From:
Monks Orchard Residents' Association
Planning

| Reference: | 19/01352/FUL |
| Address: | 56 Woodmere Avenue Croydon CR0 7PD |
| Proposal: | Demolition of a single-family dwelling and erection of a 3- storey block containing 2 x 3-bedroom and 7 x 2-bedroom apartments with associated access, 9 parking spaces, cycle storage and refuse store (amended plans and description) |

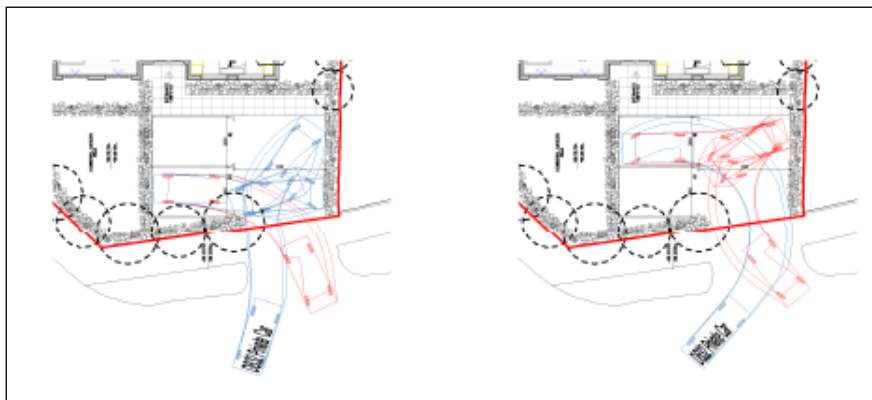
Two bays fronting Round Grove are afforded Electric charging points.

The provided swept path diagrams for access and egress to the parking bays, if all other bays are full, provide the theoretical possible manoeuvres to actually access and exit each of the parking bays Fronting Round Grove of the proposed development. However, the practical ease with which to actually make such manoeuvres would be highly suspect and probably require the skills obtained with an Advanced Driving Test. After a few attempts, and a few scrapes and dents, drivers would likely find the nearest roadside parking space and leave their cars there rather than attempt trying to navigate such complicated manoeuvres. It could be quite an entertaining spectacle, watching such complicated manoeuvres until the driver finally gives up and parks at the nearest free roadside and walks off to get the next bus! Similarly, with the Parking Fronting Woodmere Avenue (See below).

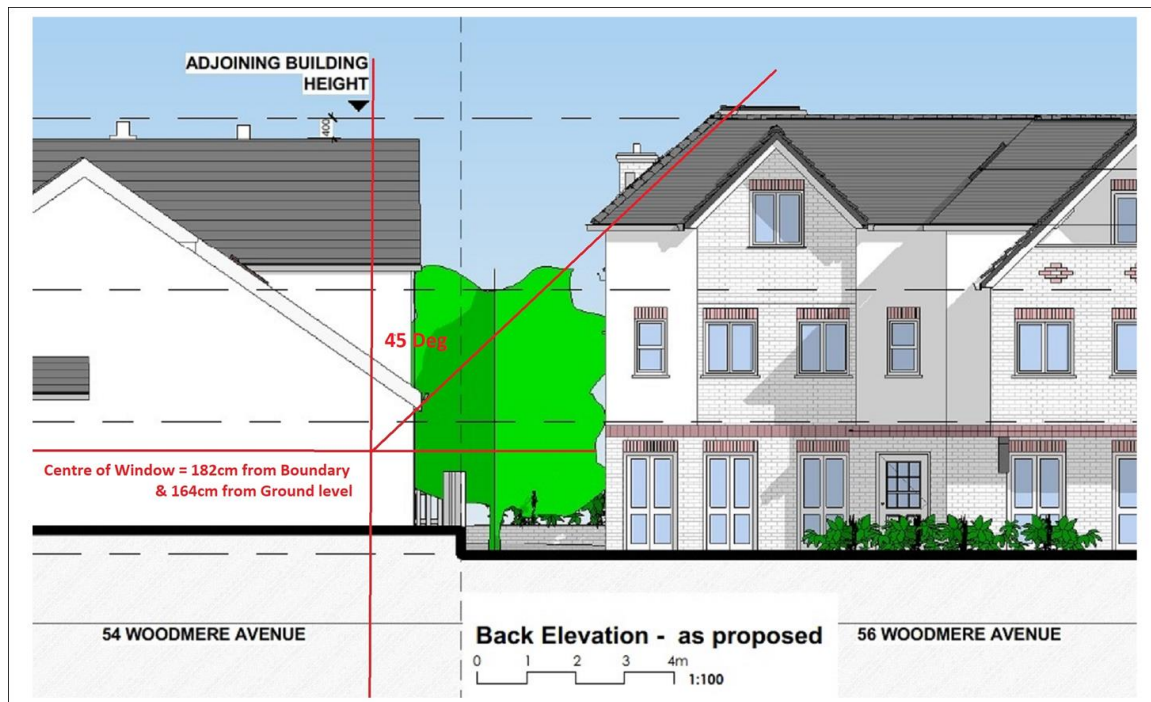
The **Supplementary Planning Document SPD2, (adopted April 2019) Chapter 2 Suburban Residential Developments** at **Para 2.11 Heights & Depths Projecting beyond Building Lines** at pages **36 & 37** describes a **45° rule** for new developments with adjacent properties.

The rear aspect window on the right viewed from the front as shown is for the residents **dining room** which is therefore classed as a **Habitable Room**.

This illustrates that the proposed development **fails to meet the 45° rule on height and will intercept the 45° projection** in relation to the adjacent property. It should be recognised that the proposed development is to be **sunk into a ≈0.6m hole in the ground** in order to meet the adjacent property's height restriction. **If the built form is NOT actually sunk into the ground**, the built form would be **0.6m higher** and the **projected 45° Rule** would show much more of the proposed development would be **above the 45° intercept projection** and **significantly greater non-compliance** to the policy. **The finish floor levels and build height is therefore extremely critical as any deviation would exacerbate the 45° Rule.**

The Planning Officer's comment at the 1st August Planning Committee meeting suggested that the nearest smaller window did not serve a habitable room and indicated that the 45° projection from the main French door windows did not intersect the adjacent proposed dwelling. **This assumption was incorrect.**

These projections are based upon the provided plans with dimensions scaled off when magnified at 112% which gives 1cm = 1m. This illustrates an overbearing nature of the proposed development on the adjacent property at **54 Woodmere Avenue.**

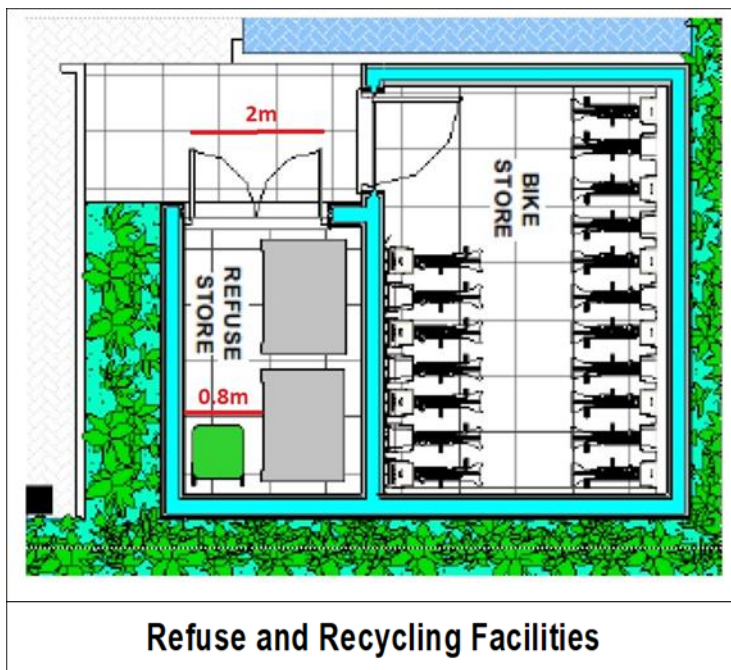
Gives requirements for new developments at **Section 4 - Flats with 5 or more units**.

The London Borough of Croydon recommends that developers follow this guidance and that Flats with up to 9 units will require an **1100ltr for general waste**, using this as a base the Council recommend **122.2 ltr's per flat**.

proposed development **does not provide this 2m clearance** in front of the bins to allow safe movement.
